**Butte Priority Soils Operable Unit (BPSOU) Final Insufficiently Reclaimed Sites – Field Sampling and Investigation Plan (FSP)
BRES No. 154 – Clark Mill Tailings NE**

RE: Butte Priority Soils Operable Unit (BPSOU) Final Insufficiently Reclaimed Sites – Field Sampling and Investigation Plan (FSP) BRES No. 154 – Clark Mill Tailings NE

Re: Approval letter for the Butte Priority Soils Operable Unit (BPSOU) Insufficiently Reclaimed Sites – Field Sampling Plan (FSP) BRES No. 154 – Clark Mill Tailings NE (dated December 1, 2021)

Figure 1 - Insufficiently Reclaimed Sites BRES-154 Clark Mill Tailings NE Proposed Sample Locations

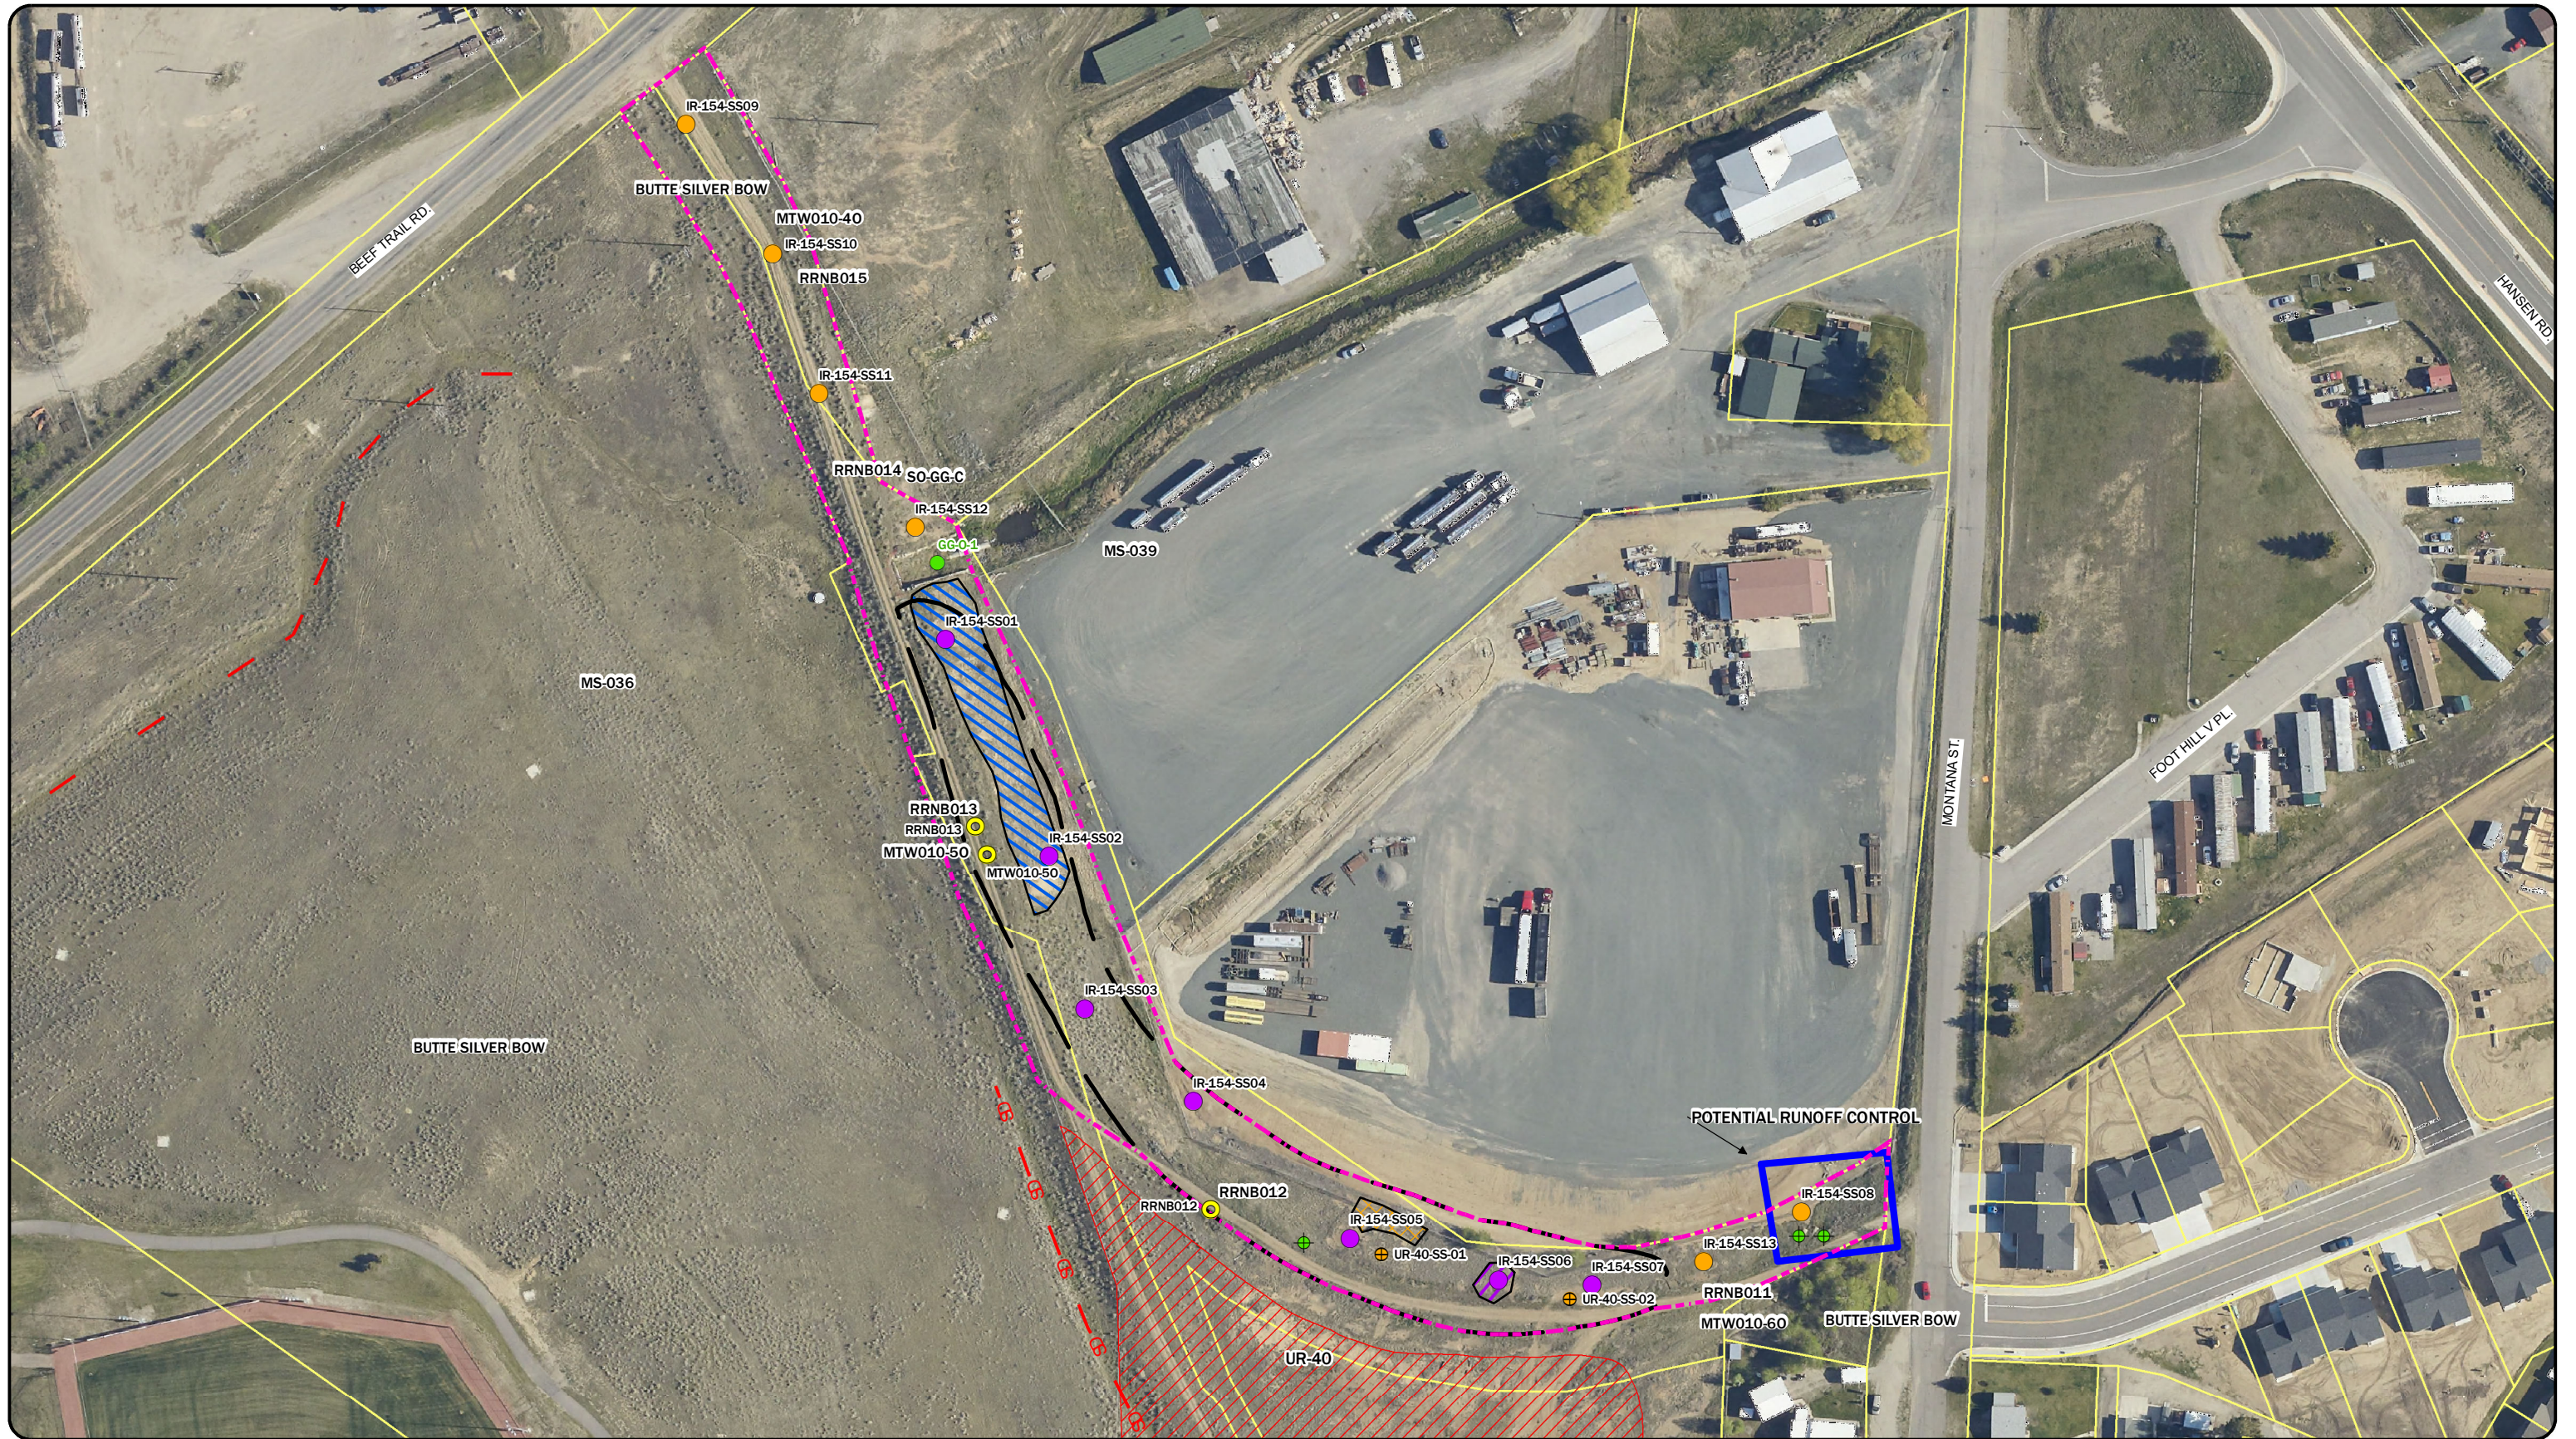
- **Agency Comment:** During the review of this FSP, it is difficult to determine exactly where the samples will actually be collected other than the general area of the proposed “dot” on the location map. EPA expects that some aliquots of the subsamples will be collected near the bottom of the slope for the unreclaimed portions, beyond the existing site boundary. Please address this concern when collecting samples in the field.

- During the review of this FSP, it is difficult to determine exactly where the samples will actually be collected other than the general area of the proposed “dot” on the location map. EPA expects that some aliquots of the subsamples will be collected near the bottom of the slope for the unreclaimed portions, beyond the existing site boundary. Please address this concern when collecting samples in the field.
- Please attach the Reclaimed quality assurance project plan to this FSP and distribute this FSP submittal as final.

Atlantic Richfield Response: Every effort will be made to safely capture samples to address the comment, and accurately characterize the site and allow final remedial design. The field team leader will also confirm sample locations and aliquots of subsamples with Agency oversight personnel as appropriate. Sample location coordinates will be recorded in the field to allow sample results to be geolocated.
